LiDAR Quality Assessment Report

AK_MatanuskaSusitna-Lot1_2011

Delivery of Point MacKenzie block

Bare-Earth DEM Anomalies, Errors, Other Issues

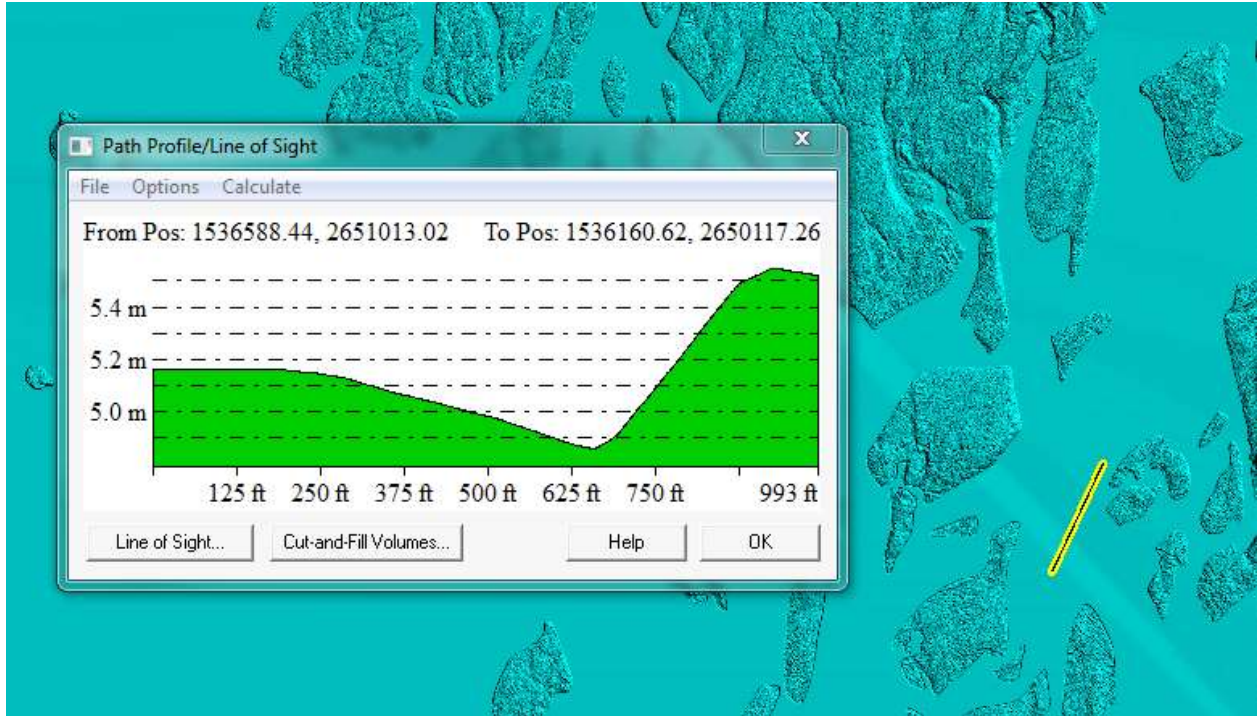
Downstream constraint not maintained in areas affected by tidal waters. Acceptable.
